Access Compliance Report Public Rights-of-Way (Curb Ramps)

Main Street: CORONEL_RD		Cross Street: CHERRY_HILL_DR		Location:	NW
ADA ID: RPRK211013121711	Ramp Type: Type 4 - Parallel	Initial Pass/Fail: Pass	Overall Compliance: No	Severity Score:	35

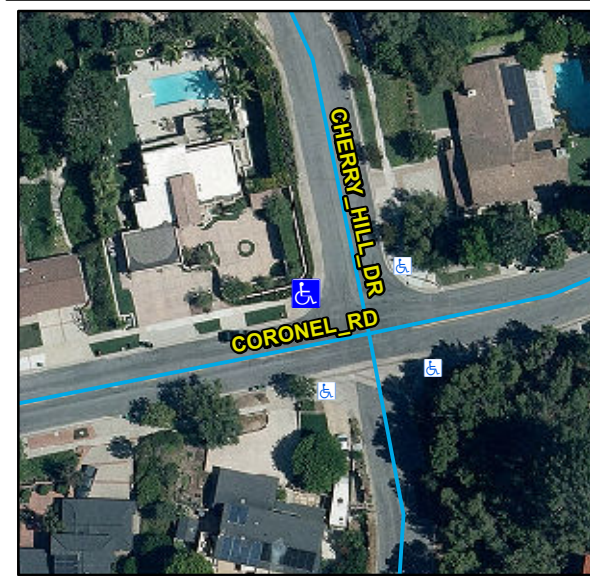
Compliance	Description	Data	Compliance	Description	Data
N/A	Ramp Length LT (in)	121	N/A	Ramp Length RT (in)	132
Yes	Ramp Width LT (in)	115	Yes	Ramp Width RT (in)	90
Yes	Ramp Run Slope LT (%)	1.5	Yes	Ramp Run Slope RT (%)	4.4
No	Ramp Cross Slope LT (%)	5.2	No	Ramp Cross Slope RT (%)	2.9
N/A	Landing Present	No	No	DWS Provided	No
N/A	Landing Length (in)	N/A	N/A	DWS Contrast	N/A
No	Landing Width (in)	N/A	N/A	DWS Length (in)	N/A
No	Landing Run Slope (%)	N/A	N/A	DWS Full Width	N/A
No	Landing Cross Slope (%)	N/A		DWS Offset Type	N/A
N/A	Landing Movement Obstructed?	No	N/A	DWS Offset Left (in)	N/A
	Landing Movement Type	N/A	N/A	DWS Offset Right (in)	N/A
N/A	Landing Shared	N/A			
N/A	Clear Space	Yes			
N/A	Clear Space To Crosswalk (in)	48			
N/A	Marked Crosswalk 1	No	N/A	Marked Crosswalk 2	No
	Crossing 1 Direction	S		Crossing 2 Direction	E
	Marked Crosswalk 1 Width (in)	N/A		Marked Crosswalk 2 Width (in)	N/A
N/A	Ramp Inside Crosswalk 1	N/A	N/A	Ramp Inside Crosswalk 2	N/A

Crossing 1 Slope (%)	6		Crossing 2 Slope (%)	5.6
	Crossing 1 Cross Slope (%)	9.1		Crossing 2 Cross Slope (%)	2.3
Yes	Gutter Ponding	No	Yes	Curb Slope	1.2
Yes	Gutter Lip Height (in)	0		Road Run Slope (%)	5.9
Yes	Gutter Run Slope (%)	1.6		Road Cross Slope (%)	7.2
No	Gutter Cross Slope (%)	6.7	No	Perpendicular Joint Present	No
Yes	Overall Surface Condition	Acceptable			
	Cross Gutter Present?	No		Spandrel Present?	No
	Replace Cross Gutter?	N/A		Replace Spandrel?	N/A

Remove & Replace Curb Ramp With Two New Directional Ramps or Equivalent. Remove & Replace Gutter.
